**Recall Service Bulletin
RSB24-120-001**

APPLIES TO: This service bulletin applies to certain model year 2022-2024 Gladiator and Metro Star, and 2023-2024 FC-94 model emergency response chassis cabs built between November 2022 and March 2024.

CONDITION: Certain driver and officer front seats may have been installed in the cab with incorrect fasteners.

Figure 3.1

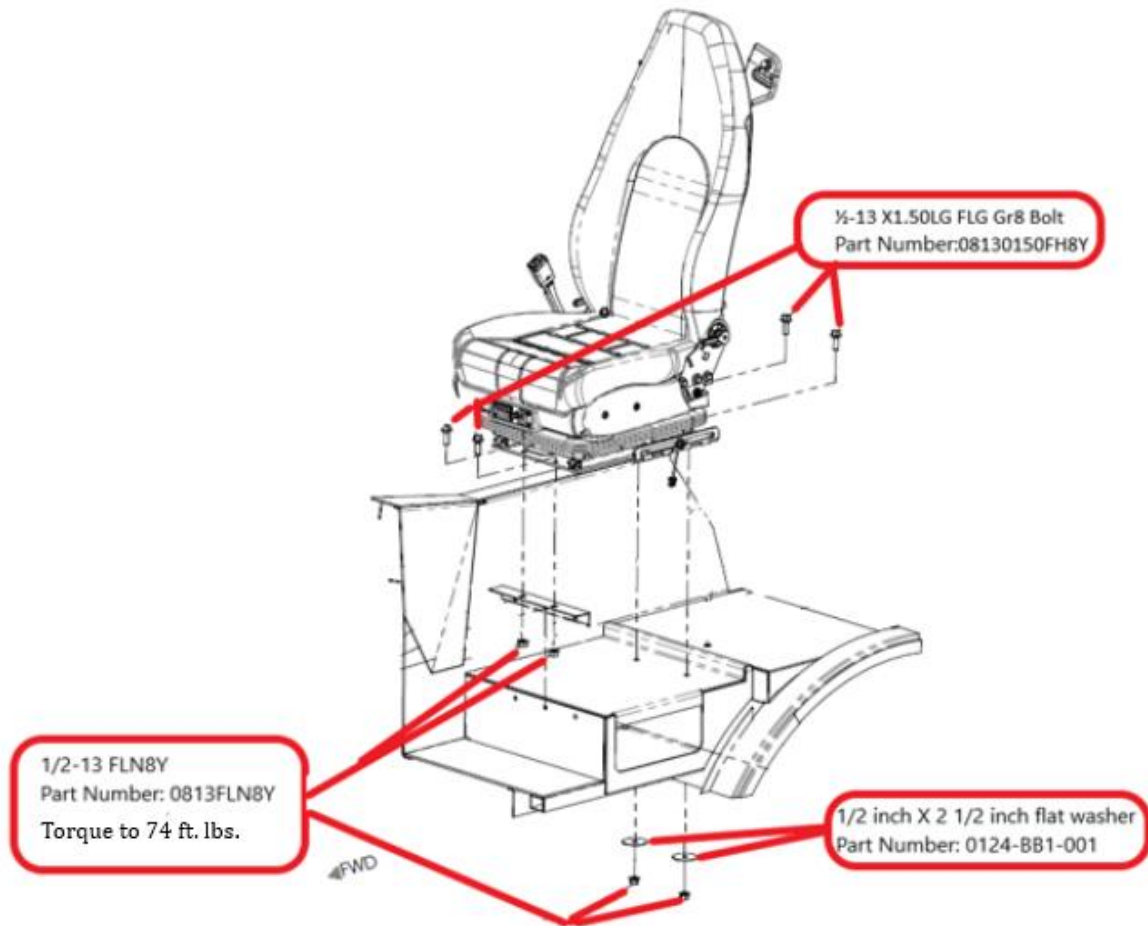
- 1) Locate driver and officer seat mounting bolts. *See Figure 3.1*
- 2) Inspect bolts and determine the diameter of each bolt.
- 3) If they are 3/8-inch diameter, bolts will require replacement with ½ inch diameter hardware.
- 4) If bolts are already ½ inch diameter, then no further action is necessary.
- 5) If bolts are 3/8 inch, replace with ½ inch hardware as shown in figure 3.1.
- 6) Torque nuts to 74 lb-ft.

CORRECTION: Inspect seat mounting for incorrect fasteners and replace fasteners if incorrect.
